Project	IEEE P802.19 Wireless Coexistence WG		
Title	Proposed draft document of 802.19.3a		
Date Submitted	August, 20, 2025		
Source	KITAZAWA Shoichi Muroran Institute of Technology	E-mail:	kitazawa@muroran-it.ac.jp
Re:	[]		
Abstract	This document is a draft document for developing a revised version of 802.19.3.		
Purpose	For developing the 802.19.3a.		
Notice	This document has been prepared to assist the IEEE P802.19. It is offered as a basis for discussion and is not binding on the contributing individual(s) or organization(s). The material in this document is subject to change in form and content after further study. The contributor(s) reserve(s) the right to add, amend or withdraw material contained herein.		
Release	The contributor acknowledges and accepts that this contribution becomes the property of IEEE and may be made publicly available by IEEE P802.19.

IEEE Recommended Practice for Local and Metropolitan Area Networks— Part 19: Coexistence Methods for IEEE 802.11 and IEEE 802.15.4 Based Systems Operating in the Sub-1 GHz Frequency Bands

Figure 1a— Duty cycle update for active system

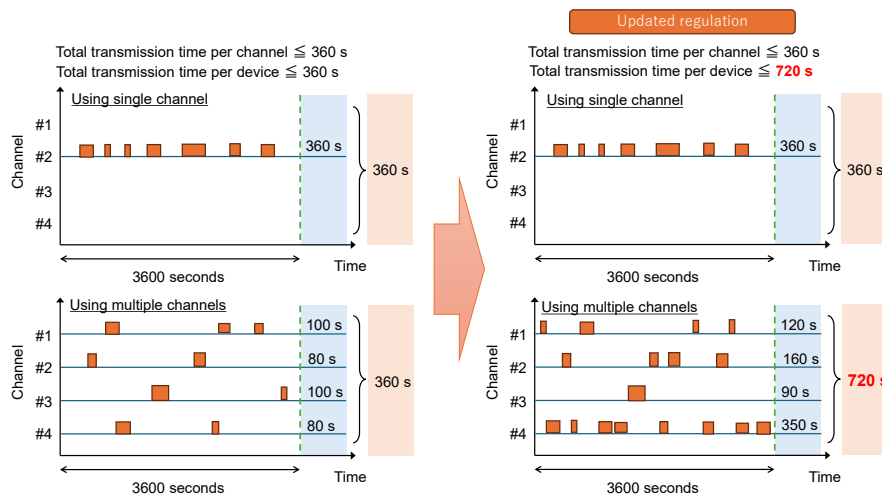
Insert new paragraph and figure after the eighth paragraph of 6.6.3.4 as follows:

The ARIB STD-T108 [BXXa] [BXXb] regulation updated to support duty cycle for active system. Each specified low-power radio station can transmit radio signal for at most 360 seconds/hours for one channel, and 720 seconds/hours for popularly two channels. Figure x show the duty cycle for active system using multiple channels.

Specified Low Power Radio Stations, about the systems with antenna power of 20 mW or less, the permissible value for occupied bandwidth was changed from 1 MHz (5 channels) to 4 MHz (20 channels) has been supported.

Figure 16a —Reduction of backoff failure by backoff suspension

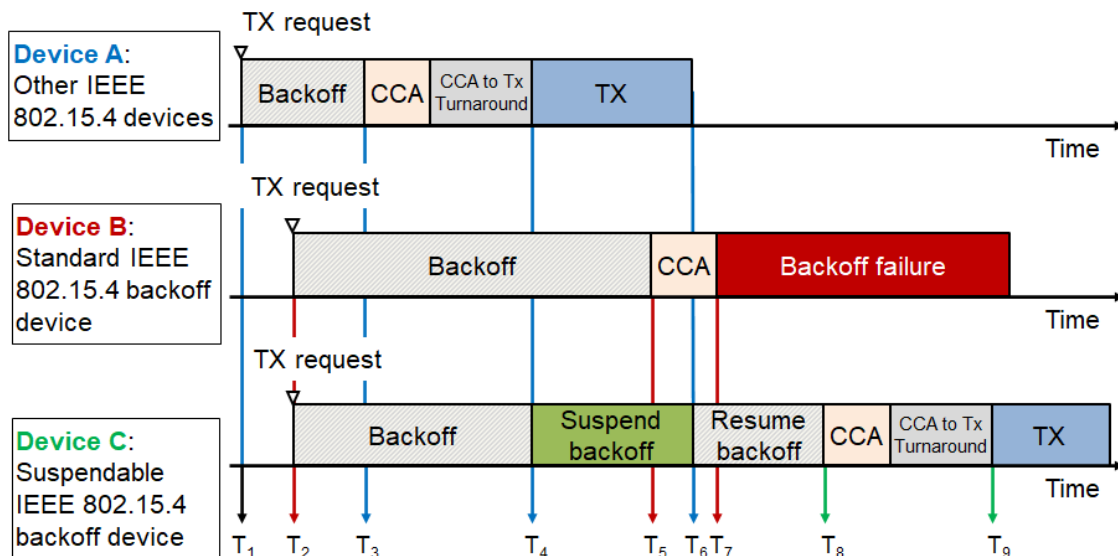
9.3.10a.1. Necessity of backoff suspension

This section validates the necessity of backoff suspension in IEEE 802.15.4 standard from protocol perspective [BXXa][BXXb]. As more and more communication technologies have been developed, IoT network environment has changed dramatically in terms of the device resource and capability, the number of devices in a network and the number of homogeneous and/or heterogeneous coexisting networks. For example, the sensor devices are conventionally battery powered. However, the grid-powered and solar-powered sensor devices have been emerging in recent years. Therefore, IoT communication technologies need to take advantages of more capable sensor devices to make network more reliable and efficient. Backoff suspension is one of functions that needs to be supported by IEEE 802.15.4 standard to benefit sensor devices without power constraint. Backoff suspension can bring benefits including: (1) improving IEEE 802.15.4 network reliability and (2) allowing IEEE 802.15.4 networks to better coexist with more channel access aggressive networks such as IEEE 802.11 networks. Figure XXa demonstrates that backoff suspension can reduce backoff failure of IEEE 802.15.4 devices, in which device A represents one of other IEEE 802.15.4 device, device B is a standard IEEE 802.15.4 backoff device and device C is a Suspensible IEEE 802.15.4 backoff device. These devices contend for channel access for transmission. At time T1, device A receives data transmission request and starts backoff. Both device B and device C receive data transmission request at time T2 and start backoff. Assume they also draw the same number of the unit backoff periods and therefore, need to backoff for the same amount of time. At time T3, device A finishes backoff and starts CCA operation, which detects idle channel. Thus, device A performs CCA to transmission turnaround. At time T4, device A starts data transmission. Since device C senses channel in each unit backoff period, it detects transmission of device A and therefore, suspends its backoff process. On the other hand, device B does not suspend its backoff and completes backoff at time T5 and performs CCA. However, at time T5, device A still transmits. As a result, device B detects busy channel and returns backoff failure at time T7. Meanwhile, device C detects the end of device A transmission at time T6 and resumes remaining backoff. At time T8, device C completes backoff and starts CCA operation, which detects idle channel as well. Accordingly, device C performs CCA to transmission turnaround. At time T9, device C successfully transmits its data. It is possible that device C may also detect busy channel, but device B detects busy channel for sure, i.e., 100% of backoff failure. If the transmission of device A completes before time T5, both device B and device C will succeed backoff. However, device C will backoff more time due to suspension. If transmission of device A starts after time T7, both device B and device C will succeed backoff with same amount of backoff time.

Figure 16b —Example of suspendable CSMA/CA behavior

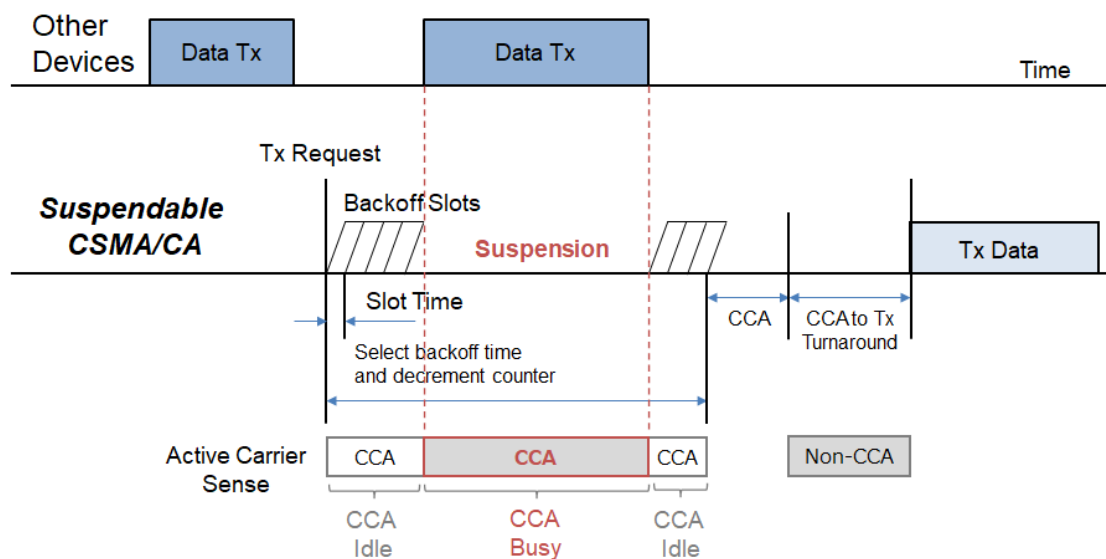
9.3.10a.2 Suspensible CMA/CA mechanism

Figure XXb shows the operation of Suspensible CSMA/CA transmission when other devices transmit data during backoff period. In details, if CCA is busy during the backoff delay period, the backoff timer shall be suspended until sensing the channel indicates that the channel is clear or `macSuspendedCsmaMaxTime` is exceeded. Upon CCA detecting clear, the backoff time shall resume. If `macSuspendedCsmaMaxTime` is exceeded, backoff ends in "Failure" and CSMA/CA algorithm terminates with a channel access failure.
